Applicant : Andrew M. Weiner  
Serial No. : 09/865,028  
Filed : May 24, 2001  
Page : 16 of 21

Amendments to the Drawings:

Figure 4a

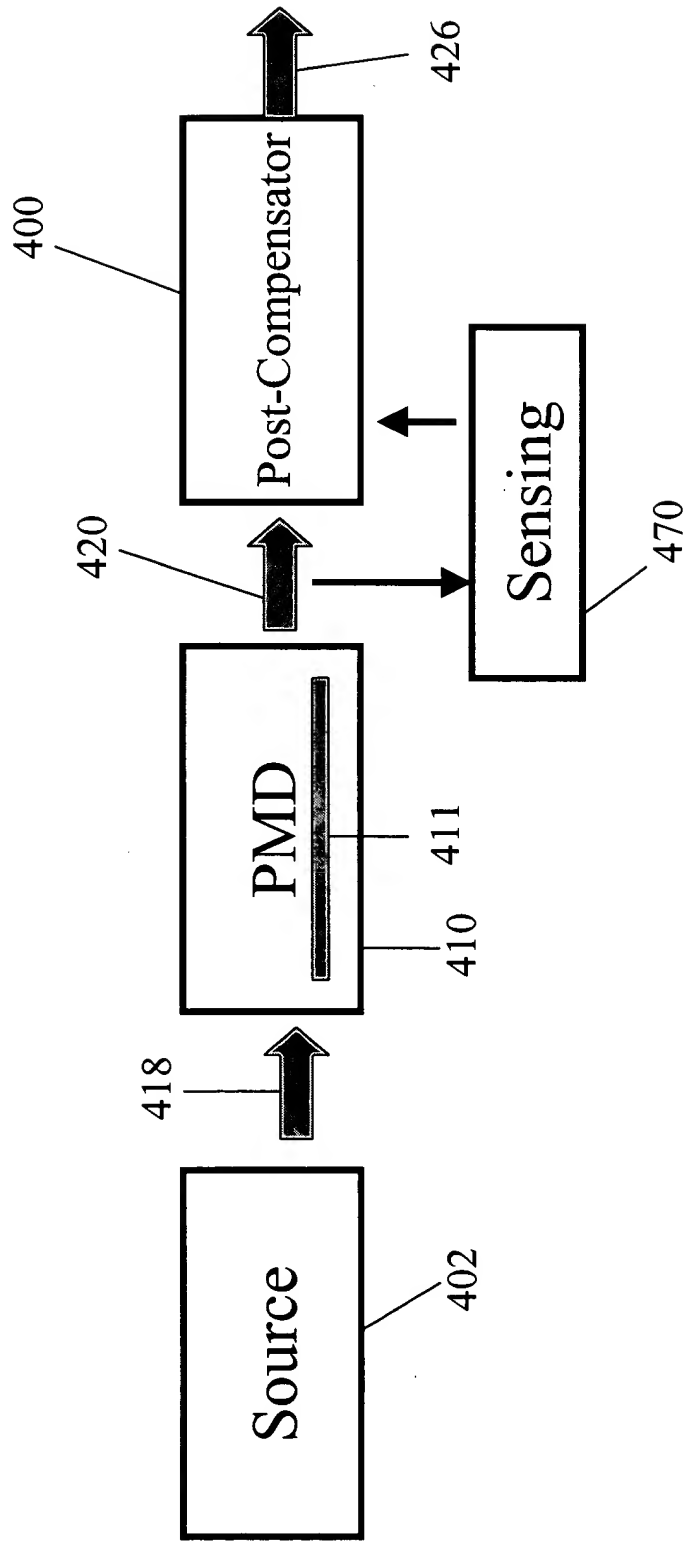
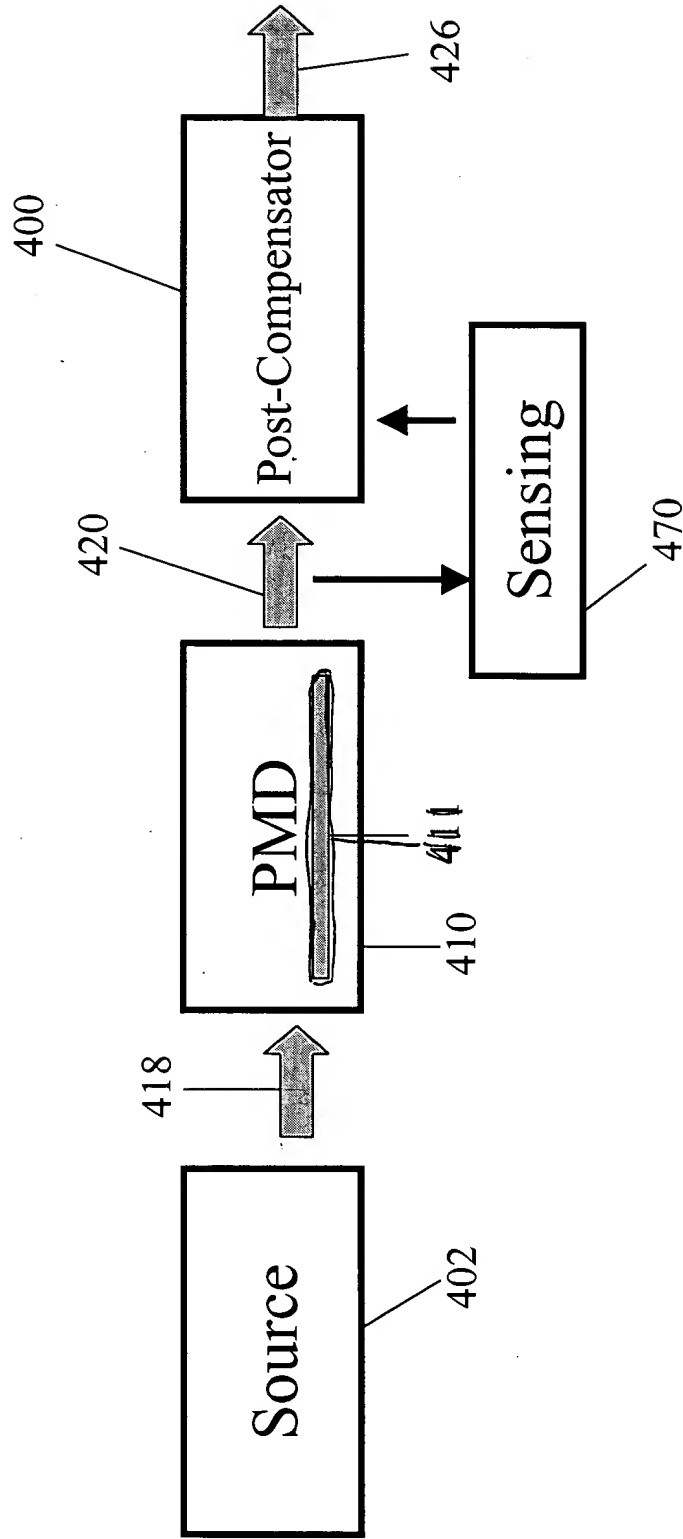
In Figure 4a, optical fiber 411 has been explicitly shown to be a component of optical system 410. Similarly, in Figure 4b, optical fiber 411' has been explicitly shown to be a component of optical system 410'.
